DESCRIPTIVE REPORT

Registry No. H-11086

Sublocality Neah Bay

Descriptive Report to Accompany Hydrographic Survey H11086

Figure 6. H11086 Prior survey comparison

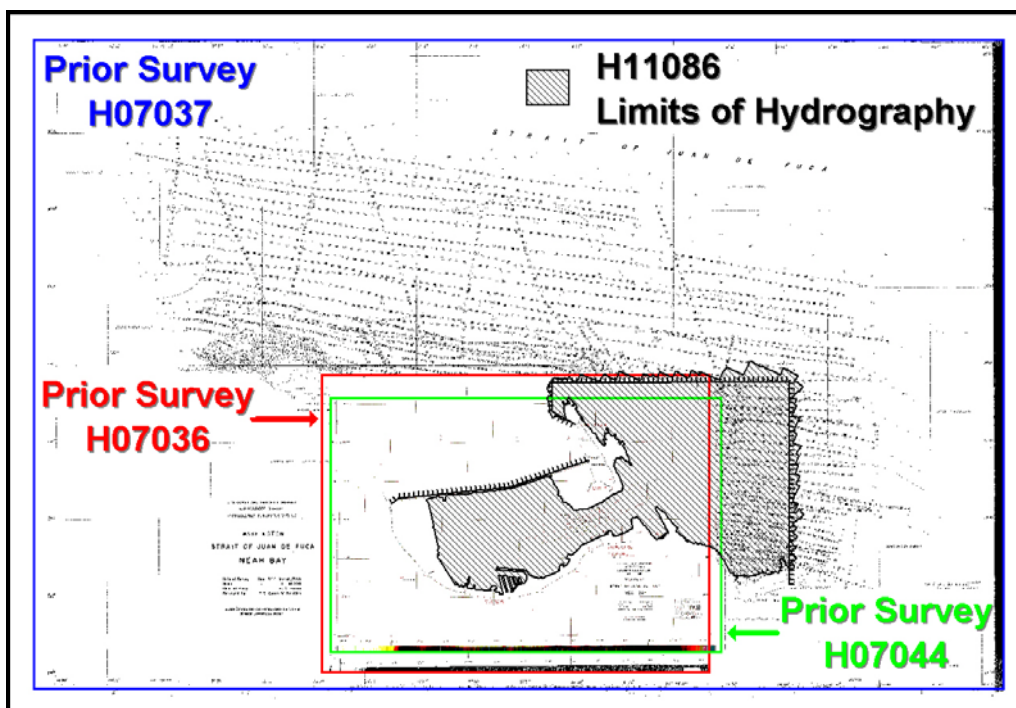
Prior survey H-7036 covers from the entrance channel of Neah Bay into the bay. Soundings from prior survey H-7036 agree well with soundings from H11086, usually within two feet.³⁷

Prior survey H-7037 covers from the entrance channel of Neah Bay seaward to the Strait of Juan De Fuca and soundings also agree well with H11086, usually within half a fathom.³⁸

Prior survey H-7044 is a wire drag survey that covers the entrance channel of Neah Bay. The current charted shoals originate with this prior survey. Soundings from the present survey H11086 do not agree well with prior survey H-7044 depths, with differences up to six feet deeper than the prior survey reported clearings.³⁹

³⁶ Differences with the prior surveys have been generally discussed below. Overall the present survey reflects a shoaler bias of 2-3 feet since the prior work. Additionally, several new cultural changes have occurred since the prior work and are graphically portrayed on the smooth sheet. Changes with the prior surveys is largely attributed to more modern data acquisition techniques. With the exception of those items discussed in the descriptive report, the present survey is adequate to supersede the prior work within the common area.

³⁷ Concur

³⁸ Concur

³⁹ Concur

Chart 18484

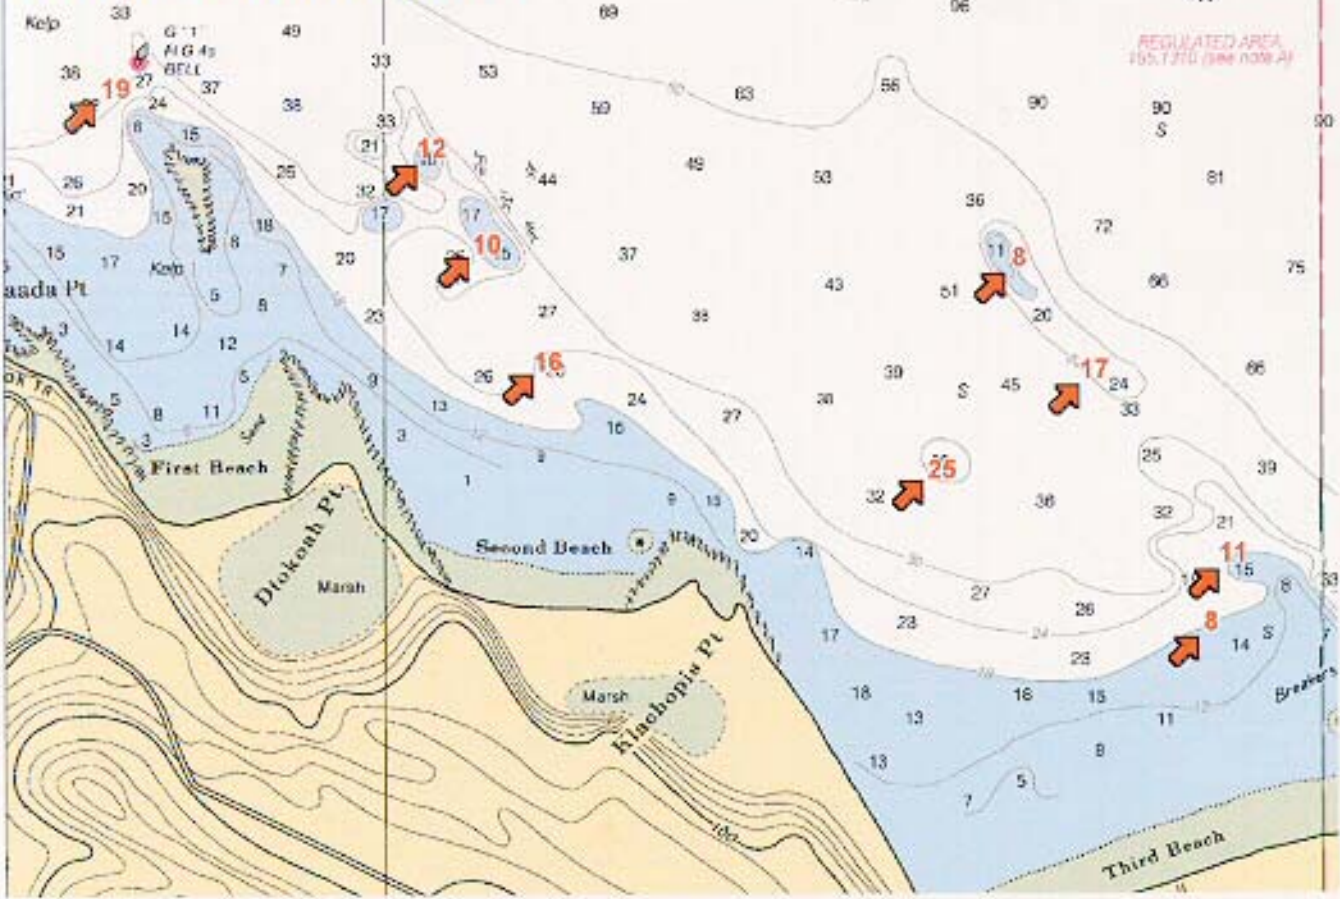
Revisions from NOAA hydrographic
survey H11086
